**Government of India**  
**Ministry of Railways**  
**Research, Designs & Standards Organisation**  
**Manak Nagar, Lucknow - 226 011**

**MODIFICATION SHEET NO. RDSO/WAG 5/15** (New No. MS 228)

**IMPROVEMENT MEASURES FOR SMOOTHING REACTORS TYPE: SL - 42 AND SL - 30**

SKETCH NO. 2

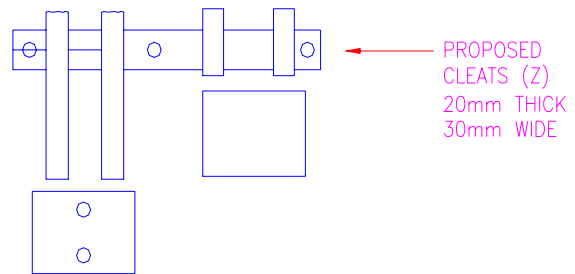
SL-42 and SL-30 if manufactured and assembled correctly will have a gap of 2.5 mm at the corners and 1 mm at the centres of flat portions of the core between the cores and the inner coils. Some cases have been reported where there was physical contact between the cores and the inner coils mostly at the corners. Due to expansion/contraction of the coil and also due to vibration the core coil insulation gets damaged and eventually there is an earth fault.

- 2.4** Re-insulate the core.
- 2.5** Correctly centre the coil on the core using curved steel wedges as shown in sketch No.2 at the corners. Remove these steel wedges after inserting flat insulating wedges in the flat portion of the core.

**Note:** The steel wedges can be manufactured by machining a hollow cylinder with tapered outer face and cutting it into 4 parts. All sharp edges and corners should be ground off and surfaces polished to facilitate insertion and withdrawal.

SKETCH No.1

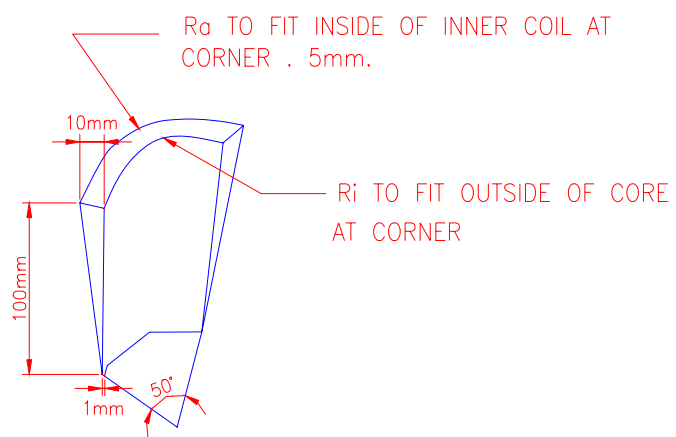
There exists a difference in levels of the two terminals on each side and the cables connected to the terminals at the lower levels pass close to the terminals on the higher level. Due to vibration in service, these cables may rub with the terminals of the higher levels and cause failure.

In order to eliminate the possibility of such failure, a cleat made of synthetic resin bonded glass fibre conforming to IS: 10192 Gr. EPL should be provided as per details in sketch No.1

- (i) Cut two cleats to size as per details in sketch No.1
- (ii) The cut pieces may be dried in oven at 110 deg. C for a period of 24 hours and then coated with anti tracking varnish.
- (iii) Fix these cleats on the smoothing reactor frame.
